REWIRING INSTRUCTIONS FROM OLDER REVISION RELAY BOARDS TO CURRENT PRODUCTION REVISION H RELAY BOARD.

Rev H

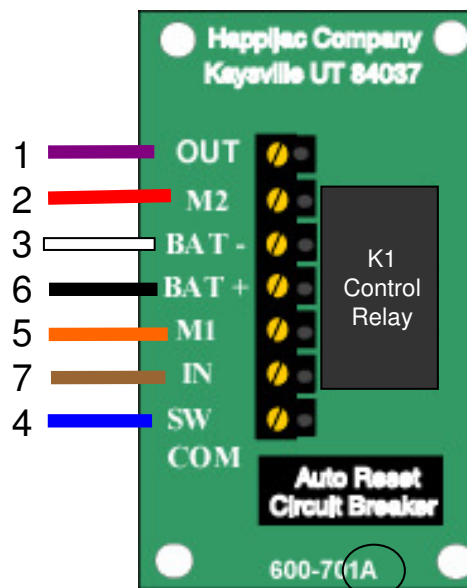
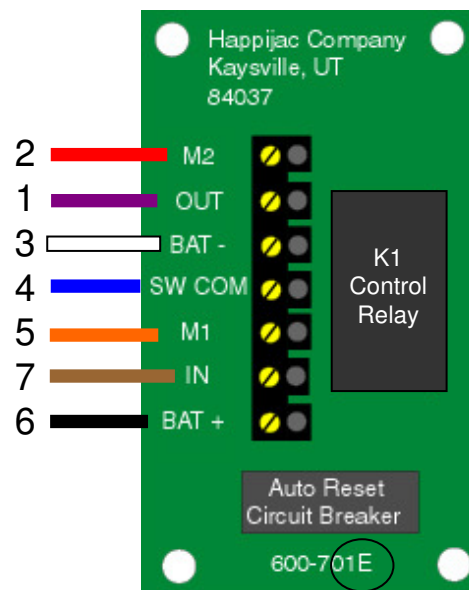
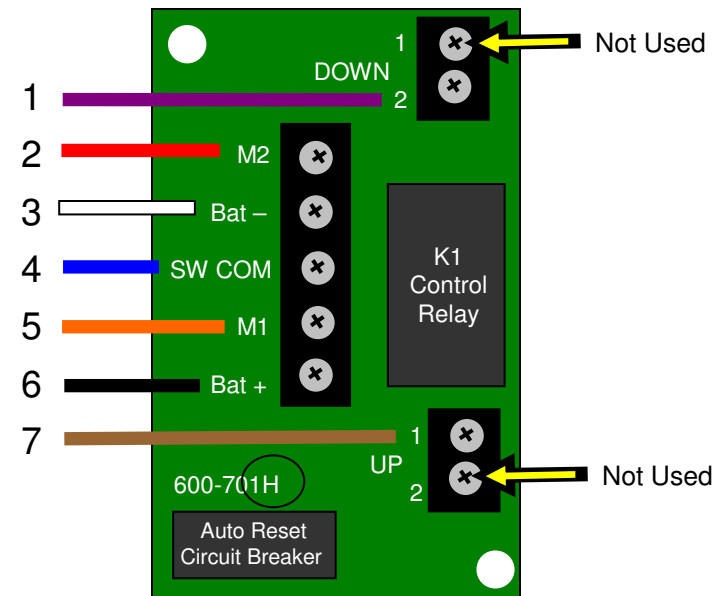
Relay boards with a revision prior to “H” are no longer available and must be replaced with a Rev H board. Although the boards function identically, they wire differently. The illustration below is designed to help in the replacement of an older revision board with the Rev H board. Your old board may say “UP” and “Down” or it may be marked “IN” and “OUT”. For purposes of conversion, DOWN = OUT and UP = IN.

It is also helpful to tag each wire with a 1 thru 7, tagged to correspond with the wire numbers shown for your old revision board being replaced. IE: If you are replacing a Rev E thru Rev G board. Your wires would be numbered in order from top to bottom (2,1,3,4,5,7,6)

The Rev H boards are also marked with the same terminal markings as the older revision boards with the exception of the UP/DOWN vs IN/OUT markings.

As you move the wires (one at a time) from the old revision board to the Rev H board insert the wires into the correct numbered position and tighten. When completed your wire tags should read 1 thru 7 from top to bottom as shown. (1,2,3,4,5,6,7)
